November 10, 2015
Medway Planning and Economic Development Board Meeting
155 Village Street
Medway, MA 02053

Millstone Village ARCPUD Special Permit Modification - Public Hearing:

ANR Plan: 59 Winthrop Street:

Sight Distance to the Left

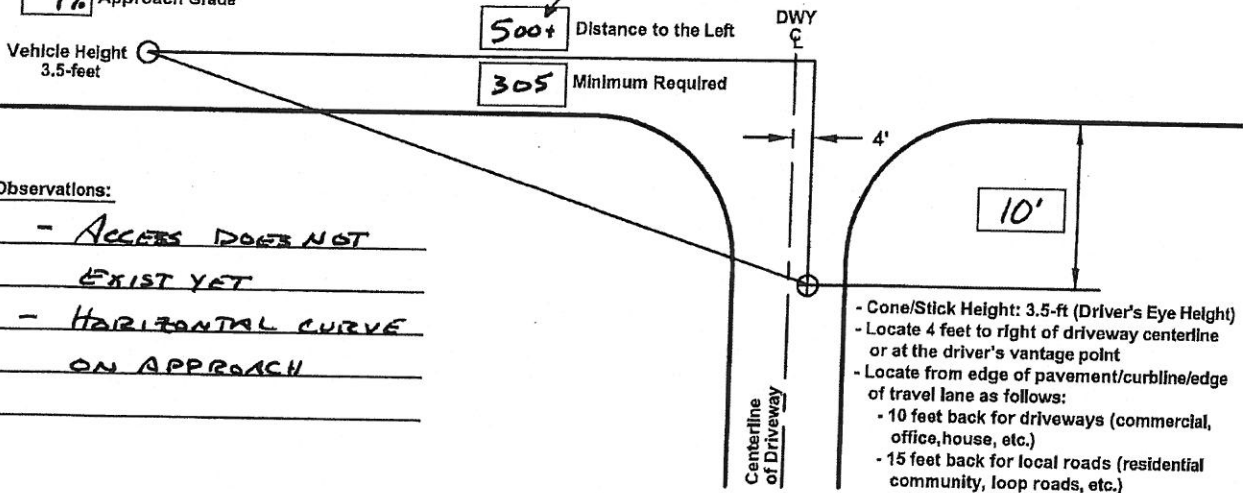
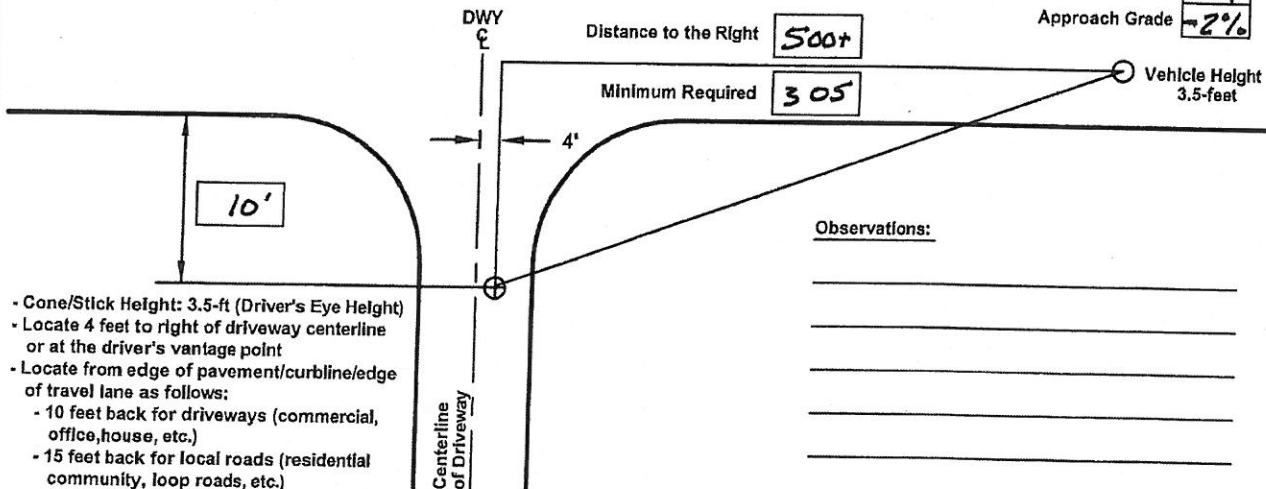
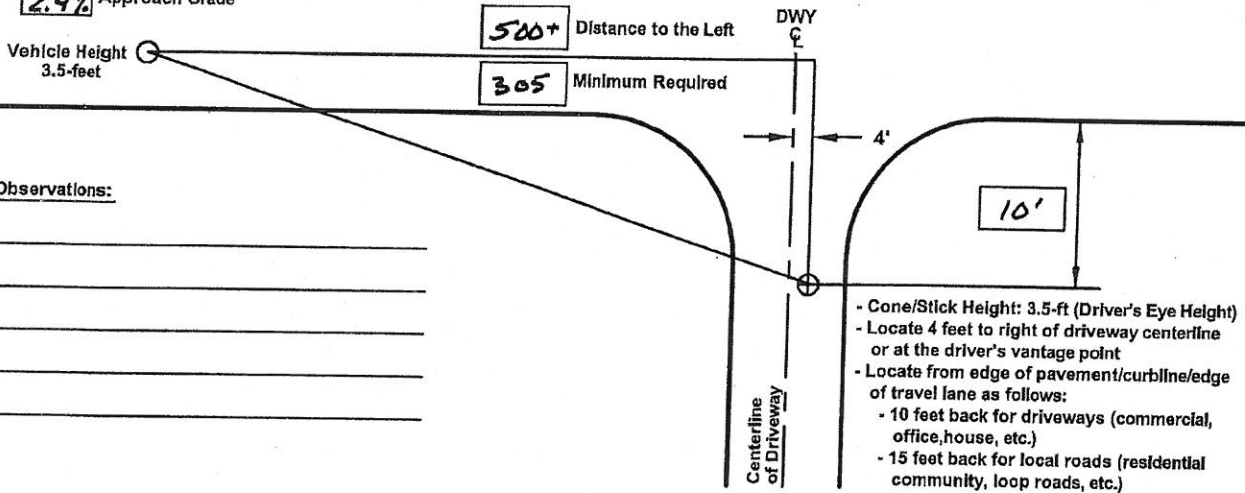
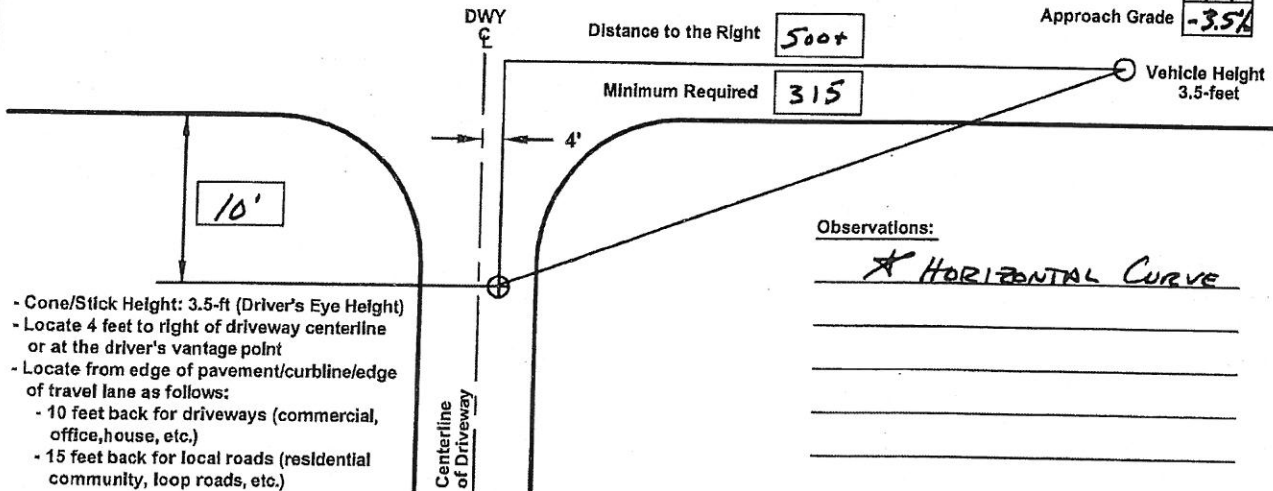
35 mph Posted Speed
 40 mph Estimated 185th Percentile Speed
 1% Approach Grade

Posted Speed 35 mph
 Estimated 185th Percentile Speed 39 mph
 Approach Grade 2%

35 mph Posted Speed
 40 mph Estimated 185th Percentile Speed
 2.4% Approach Grade

Posted Speed 35 mph
 Estimated 185th Percentile Speed 39 mph
 Approach Grade -3.5%
